Product Change Notification—PCN001212

Jul 14, 2026

We would like to inform you that Moxa is going to make changes to the CB-602I Series because of better component management. These changes will be implemented by **Aug 27, 2026**. Please review the details below to determine how these changes will affect your products and/or operations.

Product photo of the **CB-602I** models

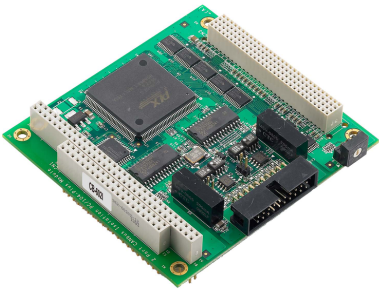
The following changes will be implemented in the new hardware revision 1.2.0:

1. Transceiver TI TCAN1044A-Q1
2. FPGA solution (CAN FD capable) for replacing CANbus controller, PCI to PCIe bridge, local bus to PCI bridge and CPLD

The hardware form-fit function stays the same.

Drivers will advance: Windows drivers to v4.1 and v3.1, and Linux drivers to v6.0, v5.0 and v4.0. The new version is also compatible with prior hardware revisions. The current version cannot work on the new hardware revision.
